HAMPTON PARK SUBDIVISION

APPLICATION NUMBER 15 DATE February 5, 2009

REQUEST Subdivision

DETAIL SITE PLAN

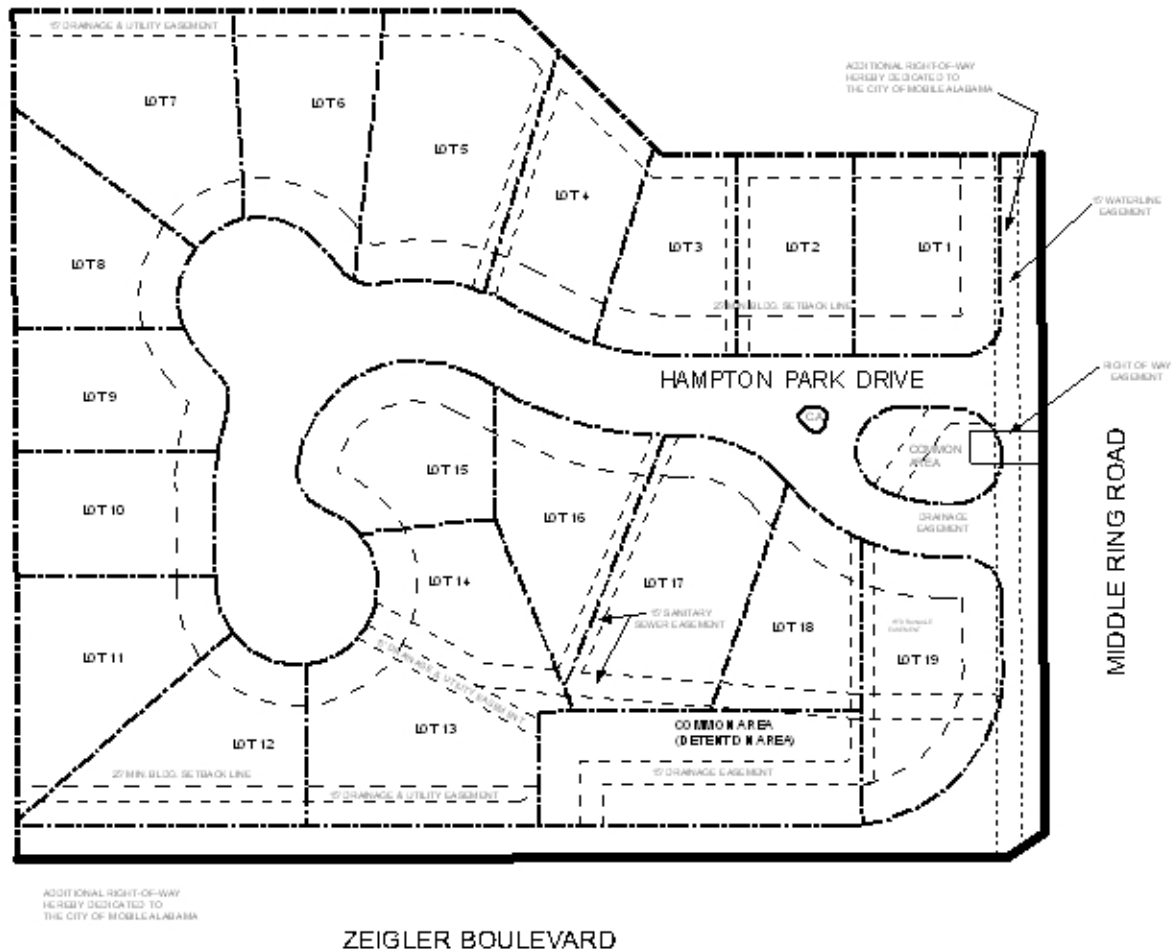
The site fronts Zeigler Boulevard and Middle Ring Road, both of which are planned major streets, and as such require 100-foot rights-of-way. As shown on the preliminary plat, the final plat should show the existing rights-of-way, and dedication of sufficient right-of-way to provide 50 feet from the centerlines of Zeigler Boulevard and Middle Ring Road (excluding service roads). Furthermore, direct access to Zeigler Boulevard and Middle Ring Road should be denied for Lots 1, 11, 12, 13, and 19.

As the site involves the creation of new streets, construction and dedication to City Engineering standards will be required. The plat shows common and detention areas, and the required note assigning responsibility for their maintenance to the property owners. In addition, the plat has been modified to provide access to the common detention area from the subdivision streets, rather than from Zeigler Boulevard.

In September of 2008, the Subdivision Regulations were amended to require cul-de-sacs to provide a turnaround right-of-way diameter of 120'. The plat should be revised to show the required additional right-of-way.

- 2) Dedication of sufficient right-of-way to provide 50 feet from the centerlines of Zeigler Boulevard and Middle Ring Road, as shown on the preliminary plat;

- 3) Construction and dedication of the new streets to City Engineering standards;
- 4) Placement of a note on the final plat stating that direct access to Zeigler Boulevard and Middle Ring Road is denied to Lots 1, 11, 12, 13, and 19, as shown on the preliminary plat;

- 5) Placement of a note on the final plat stating that maintenance of common areas will be property owners' responsibility;
- 6) Revision of the plat to show the new required right-of-way cul-de-sac diameter of 120'; and
